**RABEAA POINT OF ENTRY  
SCREENING FACILITY  
RABEAA, IRAQ**

**SIGIR PA-09-173  
JANUARY 11, 2010**

SUBJECT: Report on the Rabeaa Point of Entry Screening Facility, Rabeaa, Iraq  
(SIGIR Report Number PA-09-173)

**Figure 1. Civil site plan (Courtesy of USACE)**

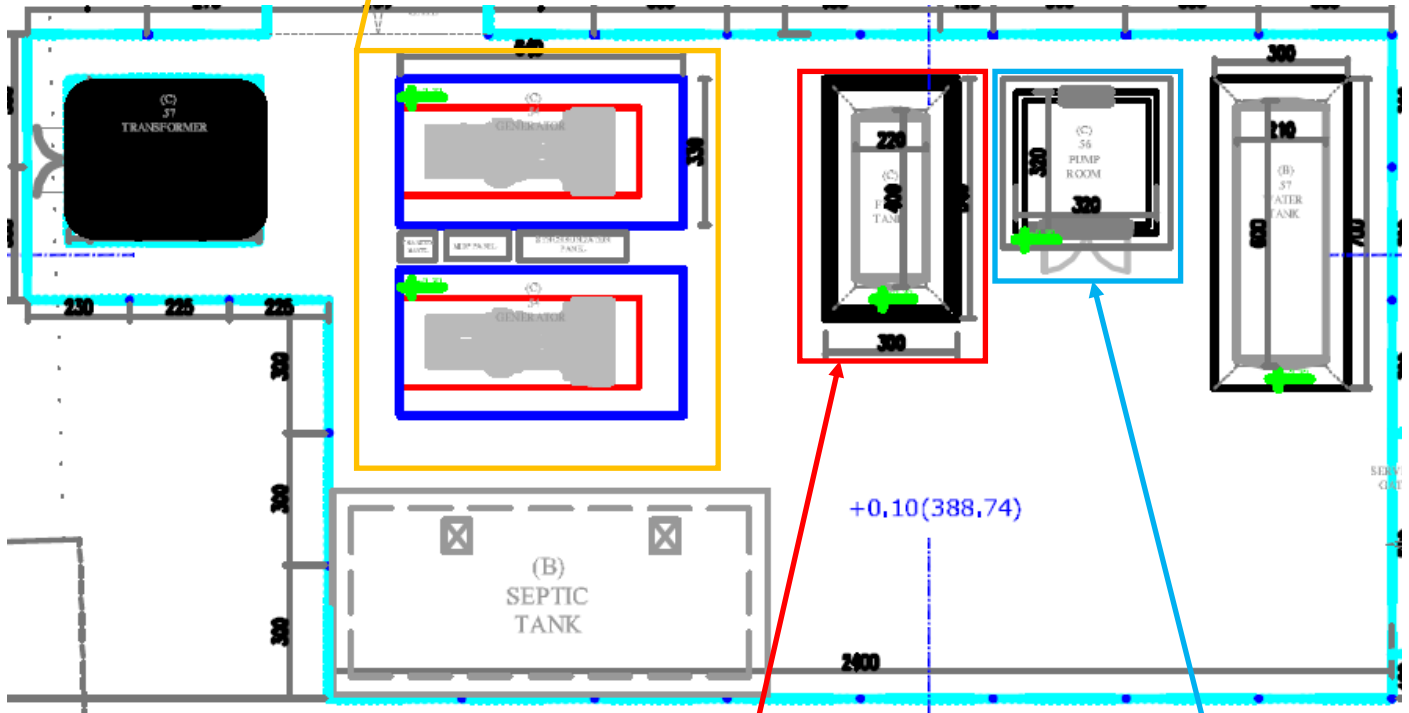
The civil design package included more architectural plans than civil drawings and the actual civil site plan (Figure 1) lacked details on topography, roadways, parking, and other typical site plan requirements. A primary concern was the lack of any drainage plan in the civil site plan. The contractor noted in the geotechnical report that drainage could contribute to future foundation problems.

Figure 5. Sidewalk detail per the 100% design drawings (Courtesy of USACE)

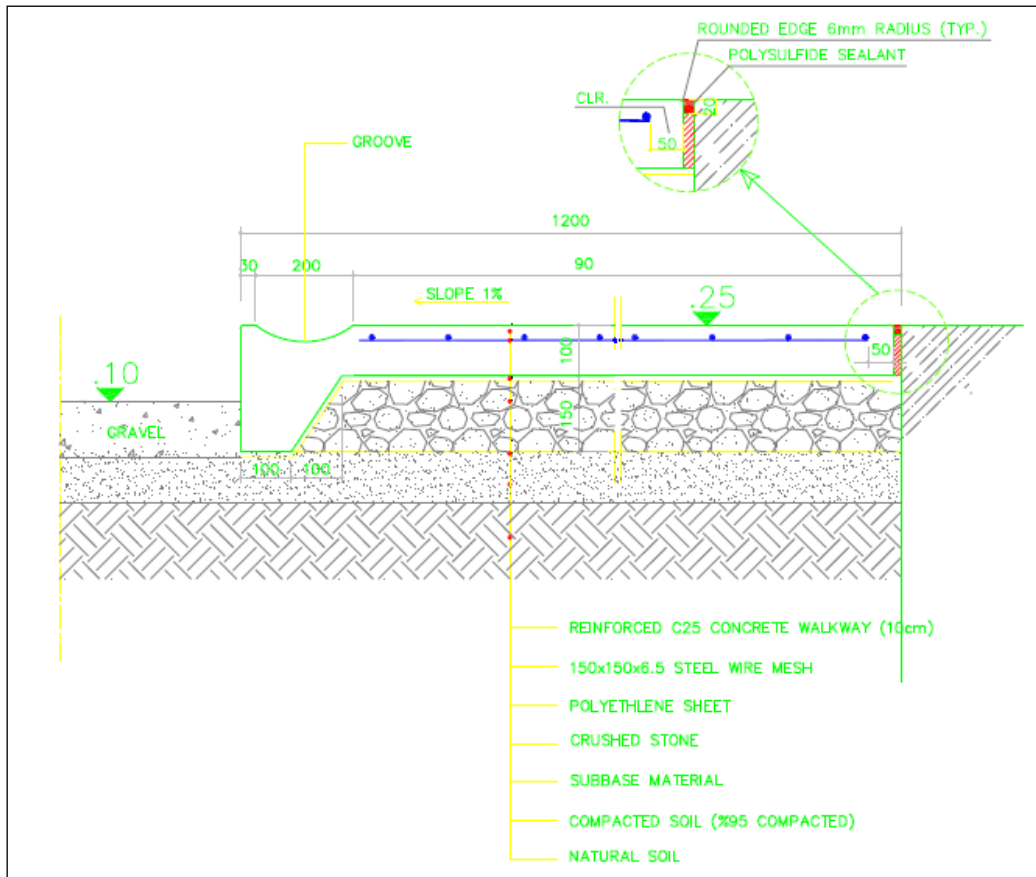
At the time of the site assessment, the exterior sidewalk was partially constructed; the construction was determined to be lacking an isolation joint next to the building, control joints, and a 200mm groove (Site Photo 9). Both the isolation joint and the groove were included in the 100% drawings submitted for approval (Figure 5). The control joints (contraction joints) were required every 1.2 meters (m) per a special note on the plans.

Figure 6. 100% Water pump room floor plan drawing (Courtesy of USACE)

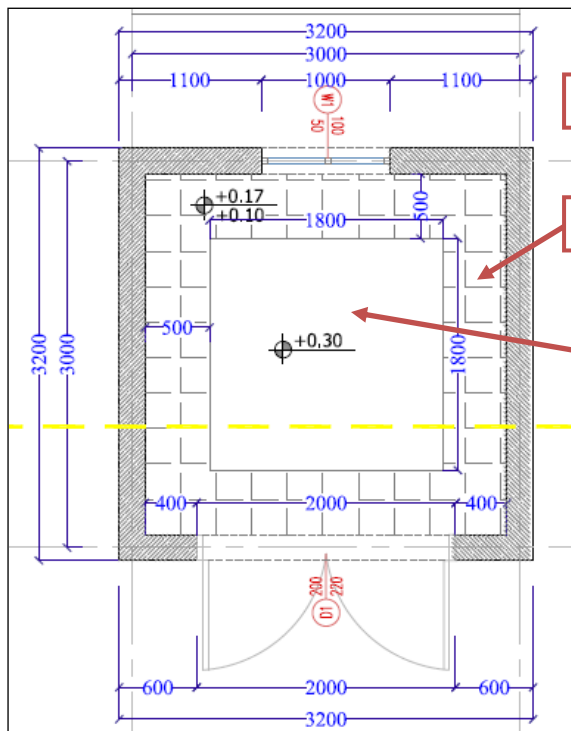
Although the construction of the water pump house was partially completed, SIGIR noted that the construction of the raised concrete pump pad was not constructed in accordance with the drawings (Figure 6 and Site Photo 10). Specifically, the raised floor as submitted on the plans was a 1.8m square raised concrete pad. The actual construction of the raised concrete pad was not configured in a square and did not allow for access against one exterior wall. Once the booster pumps are placed on the concrete pad, the access to the electrical control panel could be impeded. The original design allowed for unimpeded access all around the raised pump pad.
